RE: Submittal of the final Value Engineering Report  
Project No.: NH-051-1(25)  
County: Clarke  
P.I. No.: 122850  
SR 10 Loop  
PBS&J Project Task Order No. 30

# ***Value Engineering Study Report***

***Project – NH-051-1(25)***

***SR 10 Loop***

TYPICAL SECTION NO. 56  
TANGENT SECTION  
APPLICABLE TO PETER ST./OLYMPIC DR.  
FROM STA.92-48.24 TO STA.99-15.00 &  
FROM STA.100-75.00 TO STA.114-56

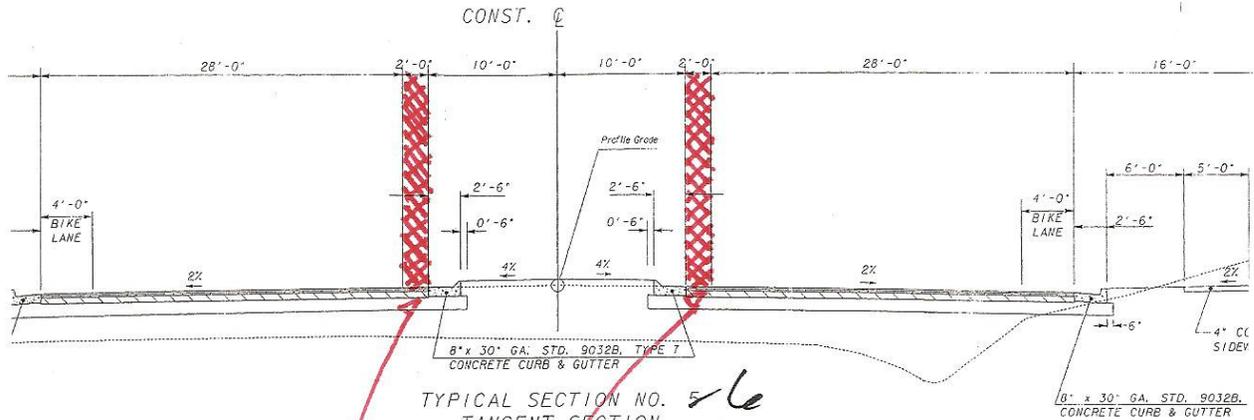
The original design calls for the construction of a 2' inside shoulder between the gutter joint and inside travel lane.

The alternative would remove the 2' inside shoulder in its entirety.

The section of Peters Street/Olympic Drive from STA.87+71.66 to STA. 114+56 is currently proposed to have a 2' paved inside shoulder between the inside travel lane and the gutter joint line. The alternative proposes removal of the 2' inside paved shoulder in its entirety to reduce pavement costs.

ELIMINATE 2' INSIDE SHOULDER ON BOTH LANES  
OF PETER STREET/OLYMPIC DRIVE WHERE  
APPLICABLE.

ALTERNATIVE NO.:  
**A-6**

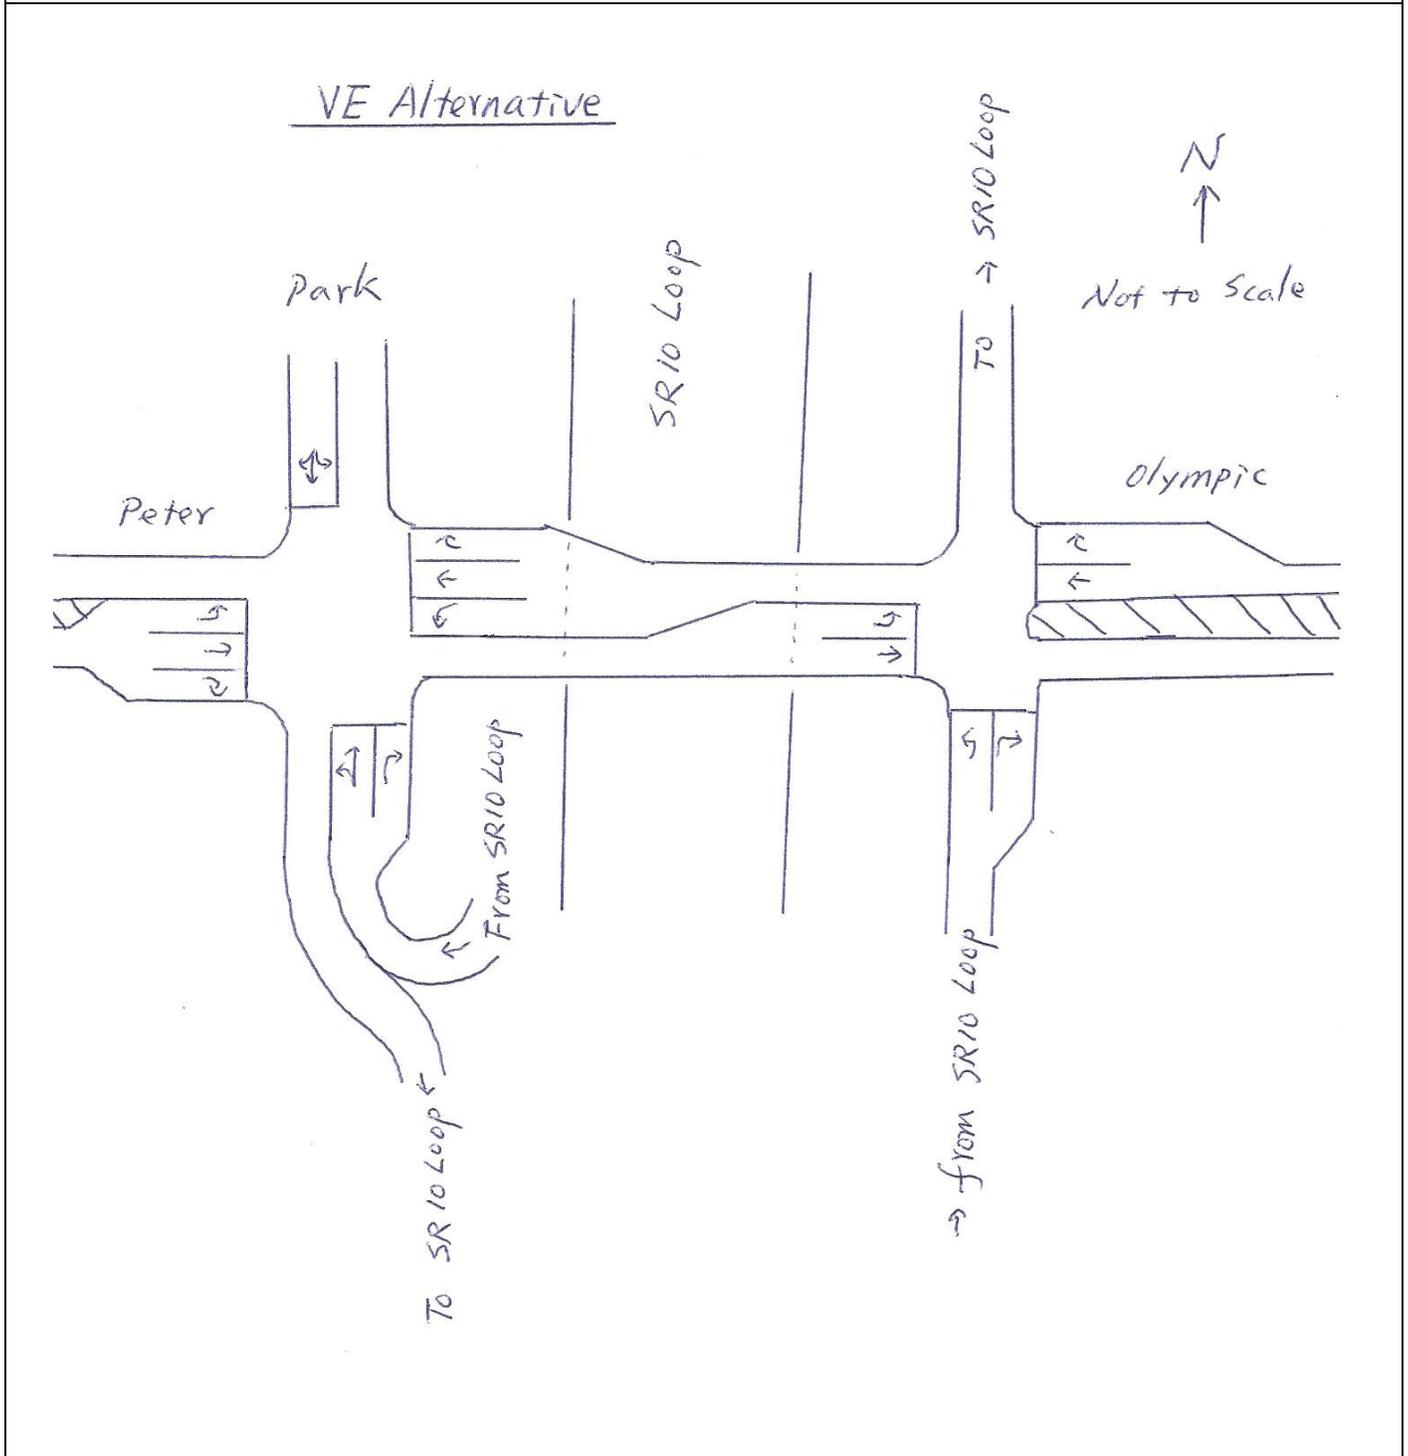
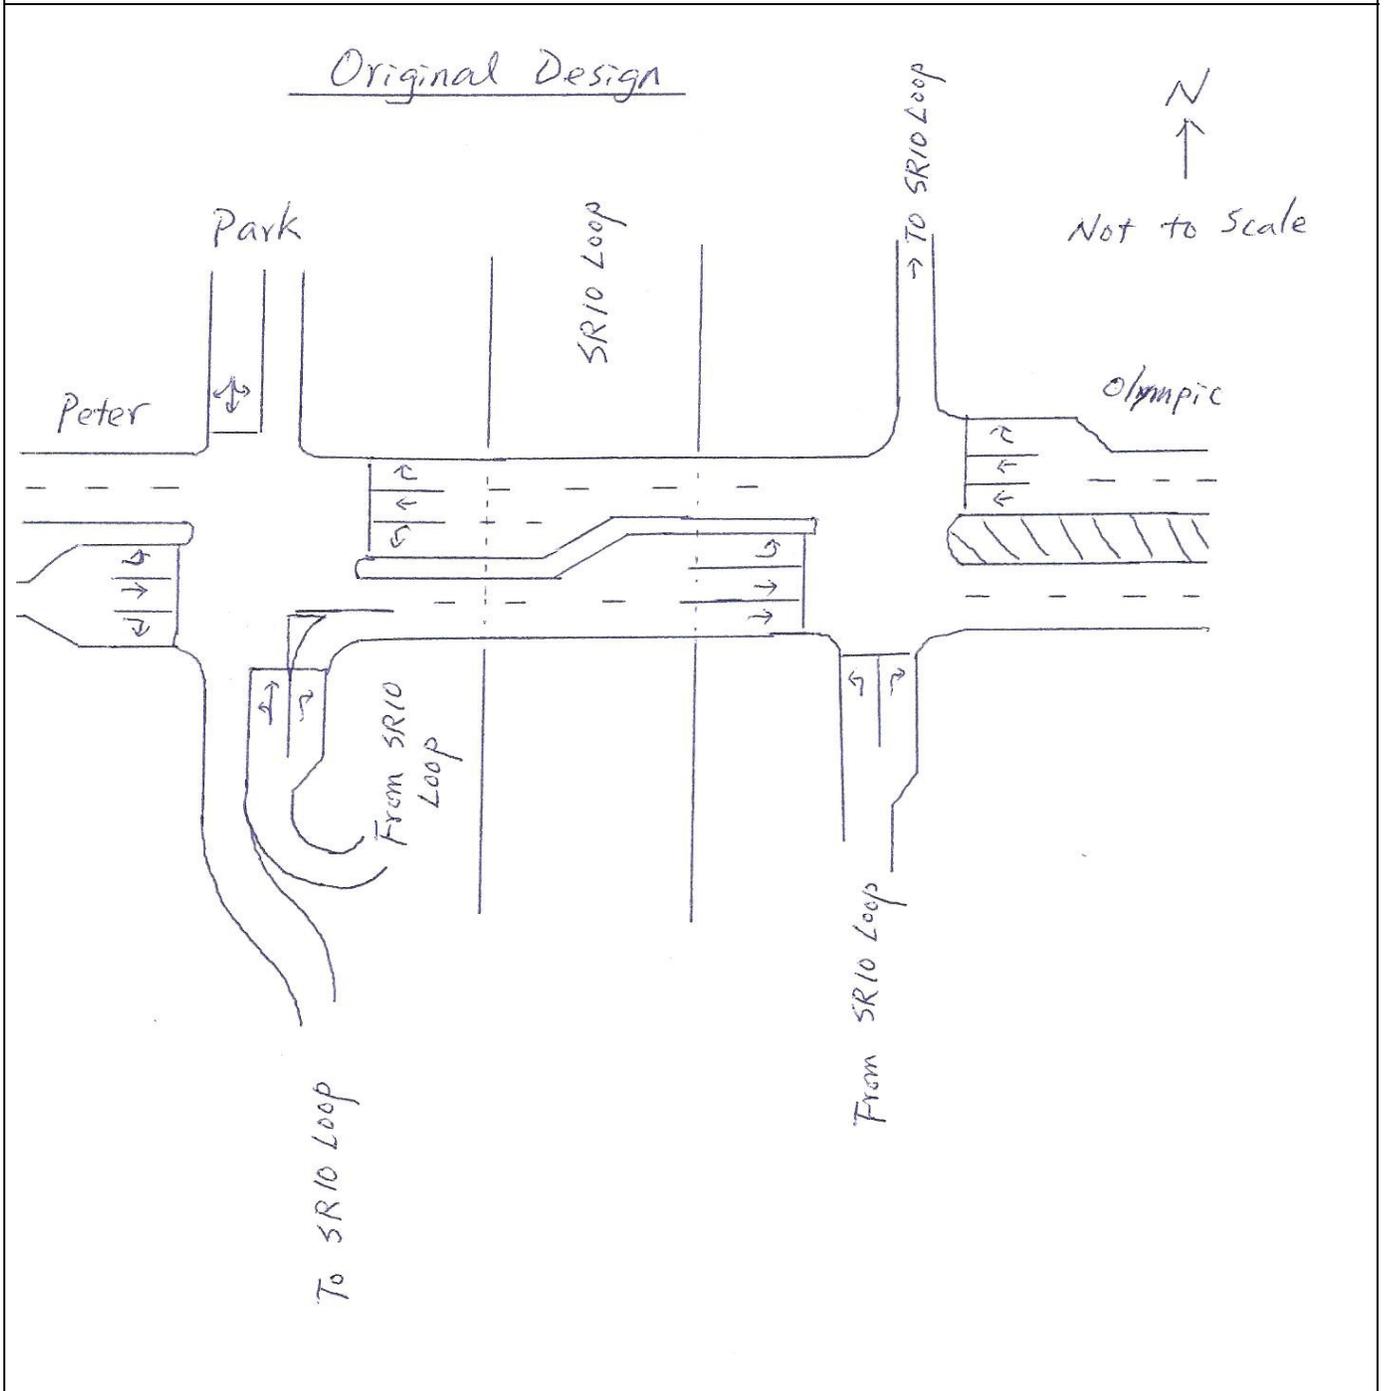
The original design calls for a four-lane divided roadway with a 20-ft median and left turn and right turn bays on the section of Peter & Olympic between the two ramp terminal intersections of the SR 10 Loop interchange.

The alternative reduces the cross-section of this section of Peter & Olympic from a four-lane divided to a two-lane undivided.

The original design follows the proposed design criteria to construct a divided roadway on Peter and Olympic. As divided roadways require a minimum of two lanes in each direction, the original design calls for a four-lane divided roadway. However from traffic operations prospective, a two-lane roadway (one-lane in each direction) would be sufficient to accommodate the design year traffic. Therefore, this VE alternative is to delete the median and construct a two-lane undivided roadway instead.

Based on a Synchro analysis, a two-lane roadway as illustrated in the following sheet would operate at LOS B for both ramp terminal intersections in the AM and PM peak hours under the design year of 2032 traffic conditions.

PROJECT:	<b>Georgia Department of Transportation NH-051-1(25) – P.I. 122850 SR 10 Loop - Clarke County</b>	ALTERNATIVE NO.:	<b>AP-15</b>
DESCRIPTION:	<b>Move logical terminus of the eastern portion of Peter Street/ Olympic Drive westerly</b>	SHEET NO.:	<b>1 of 4</b>

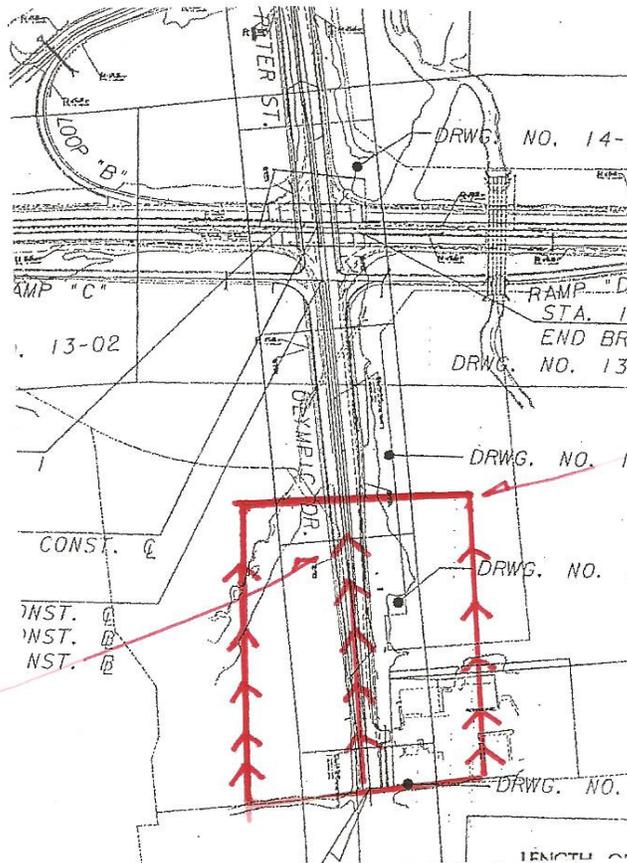
Design alternative AP-6 would reduce the footprint width of the designed improvements for Olympic Drive, making it useful to consider this design alternative in conjunction along with it, as the narrower footprint would require less taper length on the roadway to tie to existing.

ALTERNATIVE NO.:  
**AP-21**

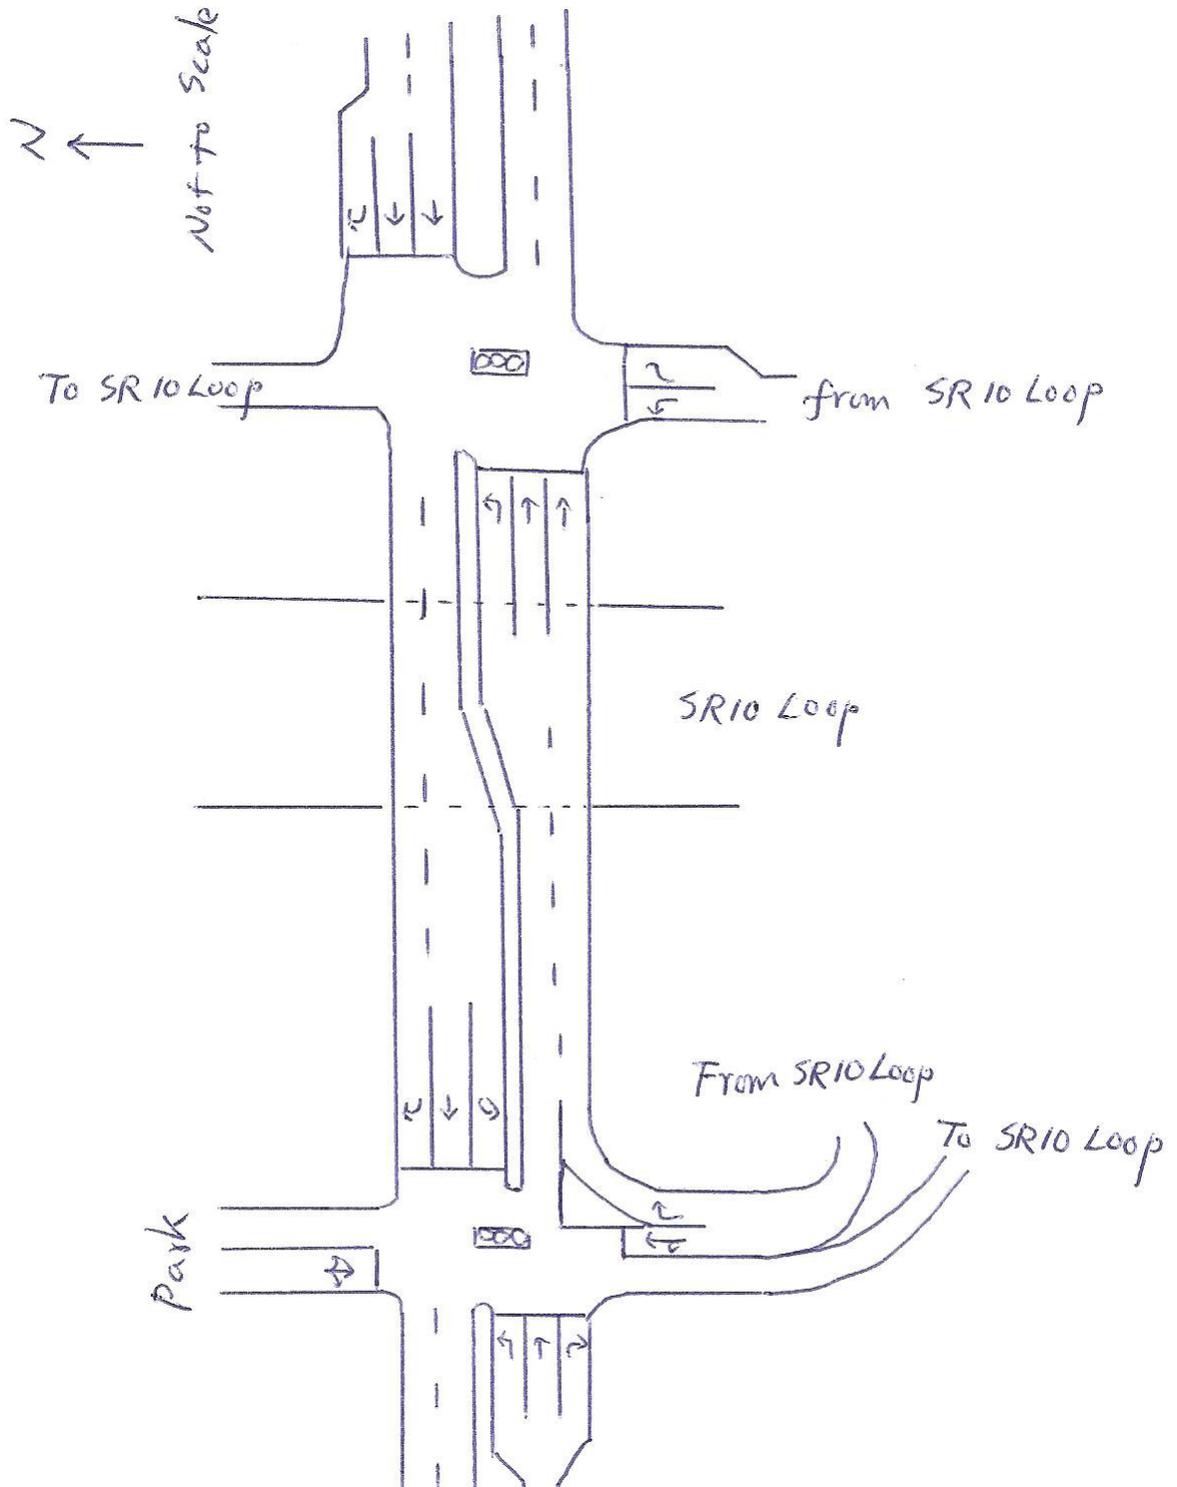
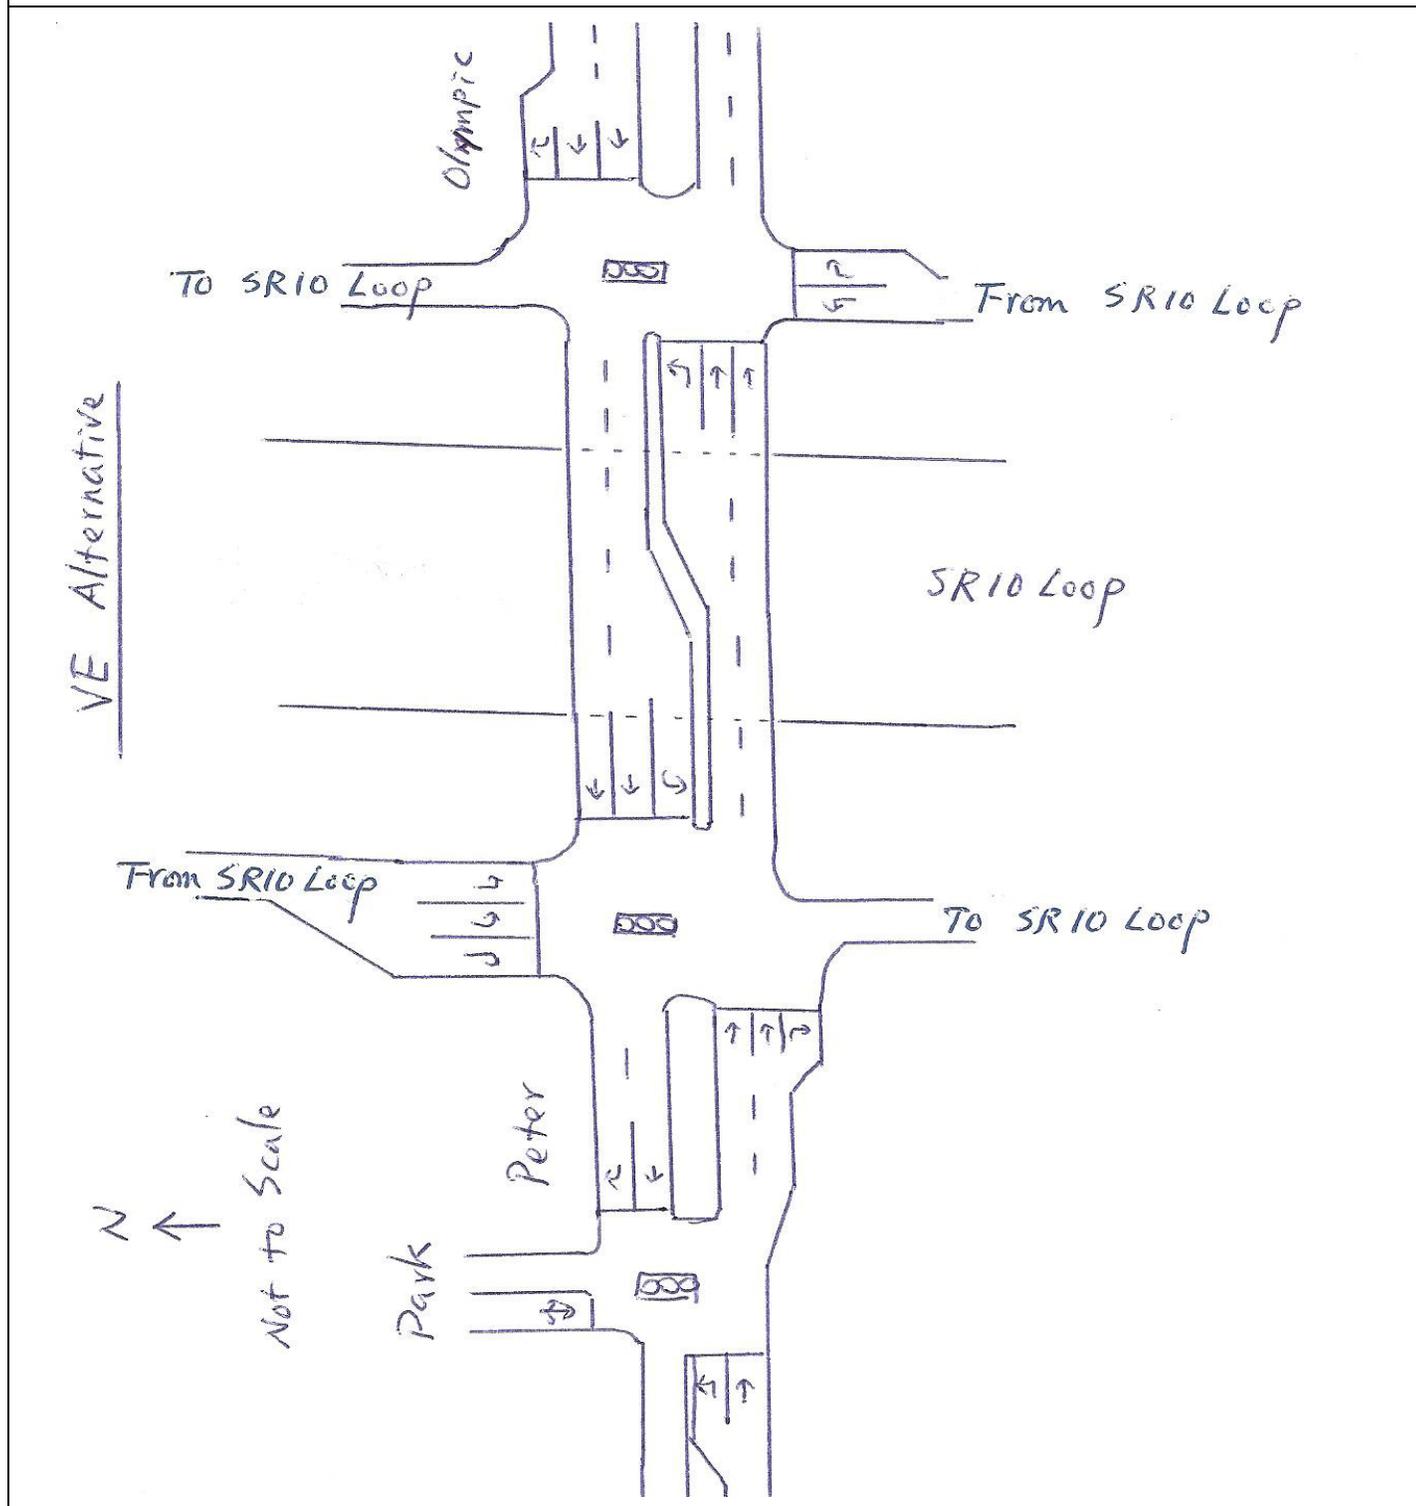
The alternative is to construct a compressed diamond interchange and delete the southbound quarter-cloverleaf exit loop and a southbound entrance ramp outside the loop from the original design.

Page 9 of the Project Concept Report, dated June 12, 2000, included a table showing the 6 interchange forms the project examined, and compressed diamond (#4) was one of them. The report stated that a compressed diamond provided for adequate operation and safety improvements, and the cost would be in an acceptable range, however, projected turning volumes would be more efficiently handled with a clover leaf configuration. Based on a Synchro analysis conducted by the VE team, a compressed diamond interchange with the laneage illustrated in the following sheet would operate at LOS B for both ramp terminal intersections in the AM and PM peak hours under the design year of 2032 traffic conditions. This analysis confirmed the conclusion stated in the Project Concept Report that a compressed diamond interchange would provide for adequate operation. A few concerns were raised in the Project Concept Report regarding a compressed diamond interchange. One concern was that the short left turn storage under the SR 10 Loop bridge could cause traffic to queue thru the adjacent intersection. Mr. Marwan Abboud from Arcadis who prepared the Project Concept Report responded that the proposed diamond phasing would prevent this from being a problem. Although Mr. Abboud didn't elaborate why, a possible explanation is that the two signalized intersections of a compressed diamond interchange would functionally operate as one signalized intersection, and the signal would operate in a split phase allowing each direction to move in sequence hereby preventing vehicles from queuing between the two intersections. A second concern was that a compressed diamond would result in three signals on this section of Peter and Olympic as opposed to two signals under the original design, because the park entrance will need a traffic signal. Under the original design, the park entrance and the western ramp terminal intersection will share one traffic signal, while each location will need a traffic signal under the compressed diamond interchange configuration. It should be noted that the Park would have different peak hours than the subject interchange. Parks normally generate most traffic on weekends while this project uses weekday peak hours as the design hours. This is evidenced by the design hour traffic volumes provided in the Project Concept Report. The Report used a minimum number of 5 vehicles per hour (vph) to indicate the traffic entering and exiting the Park during the weekday peak hours. This indicates that the traffic signal at the Park entrance would show a green phase to Peter Street most of the time during the weekday peak hours, and thus would have minimum impact on the traffic operations along Peter and Olympic at this interchange. It is also noted that the original design includes a 4-ft bike lane and a 2-ft left side buffer between the inside travel lane and the median. The 4-ft bike lane and 2-ft buffer were kept in this VE alternative in order to have an orange to orange comparison. Removals of the 4-ft bike lane and 2-ft buffer are recommended under separate VE alternatives.

DESCRIPTION: Delete sidewalks and bike lanes on Peter Street/Olympic Drive; build one 10' multi-use trail on one side of the road

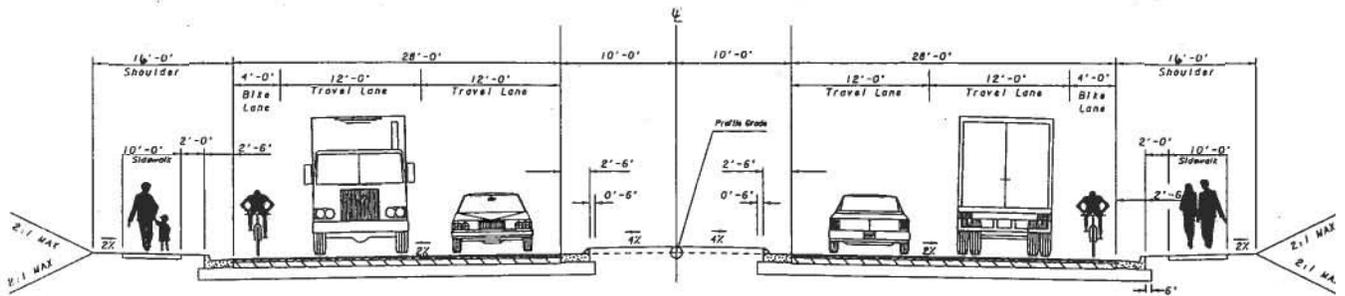
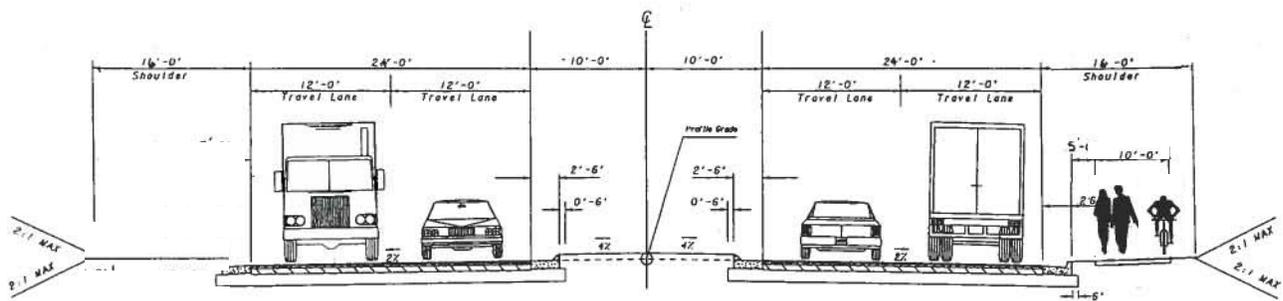
The proposed design would locate the bicyclist adjacent to trucks and automobiles moving at 45 MPH. By removing them for the travel lanes and locating them adjacent to the pedestrians, the project safety would be improved. In this geographical area, there is a county park and residential area nearby. Possible usage would be by folks riding from the residential area to the park.

There are bike lanes in each direction from station 87+71.66 through the end of the project to station 116+14.02. The alternate is to remove the bike lanes from the road way deleting the 4' of road width, and providing one multi-use trail.
